Downtown Development Review Overlay

Staff Report to the Committee

Case No: 15DDRO1011-CB & 15DDRO1012-CB

Property Address: Case #15DDRO1011:
435-437 S. 3rd Street and 456 S. 2nd Street / Old Water Company Block

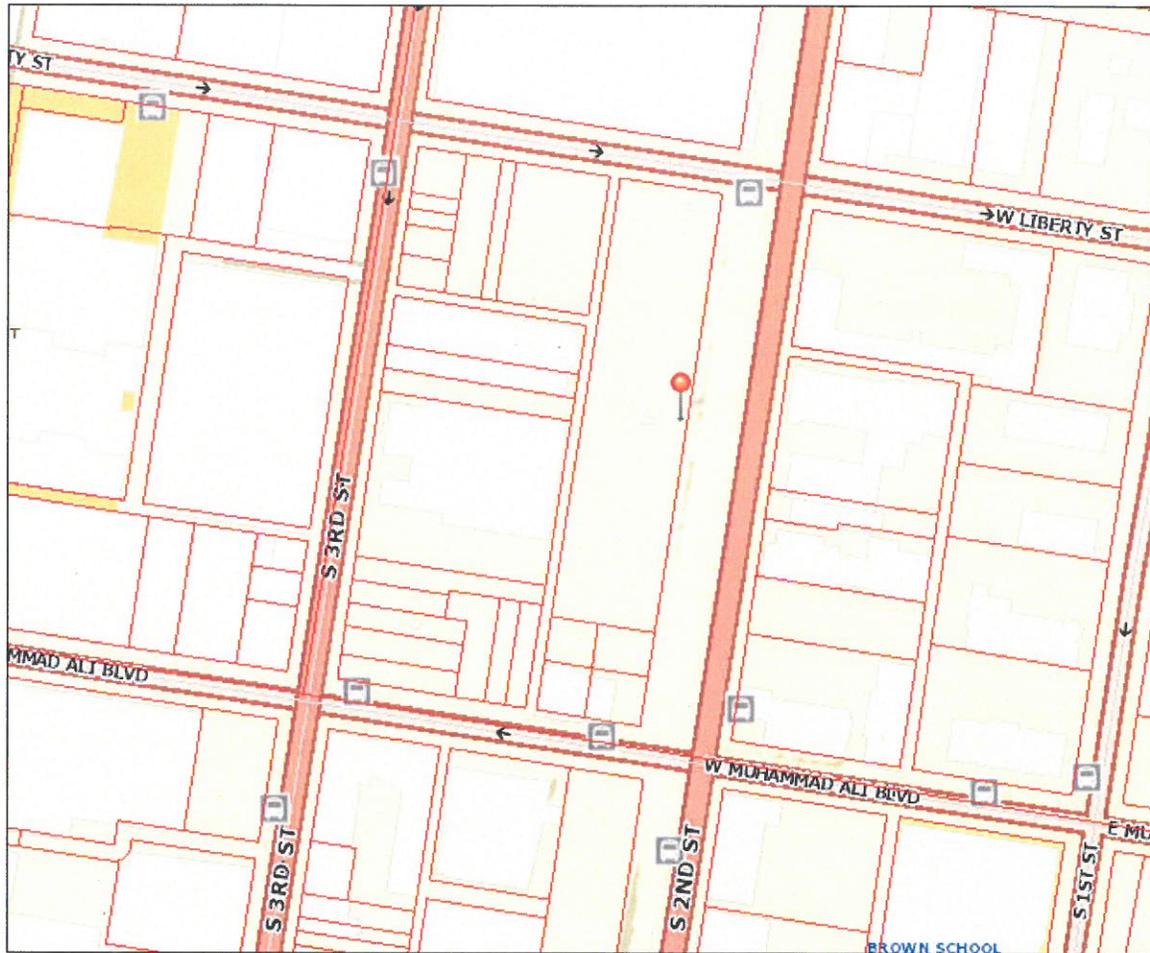
The **Alley Elevation (South Side, Looking North)** of the development features a vehicle entry access point to/from the parking garage and an entrance to a proposed lounge. It should be noted that this elevation is projected from a new alley that would be located parallel to Muhammad Ali Boulevard. As such, it does not depict any development located in the Phase II area (situated between the alley and Muhammad Ali Boulevard to the south), which includes an existing surface parking lot and the Odd Fellows Building. The first three stories feature CMU and masonry walls with precast panel. In addition, the two tower wing facades are visible, with the shorter tower having some precedence from this vantage in terms of its width along this frontage. Because of its location along an alley, this façade is not highly articulated for the first three stories. As part of Phase I, it will have a lack of public exposure since it is situated approximately 175 feet from Muhammad Ali Boulevard, where there are some trees lining the roadway, and partially behind the 4-story Odd Fellows Building. It is assumed that development as part of Phase II would further obstruct visibility of the lower portion of the façade. The multiple facades of the building continue to feature a variety of exposed glass curtain wall and punched window openings in masonry walls. A metal signage panel is shown on the first floor, located on the corner adjacent to 2nd Street, and reads “OMNI HOTEL & RESTAURANTS”.
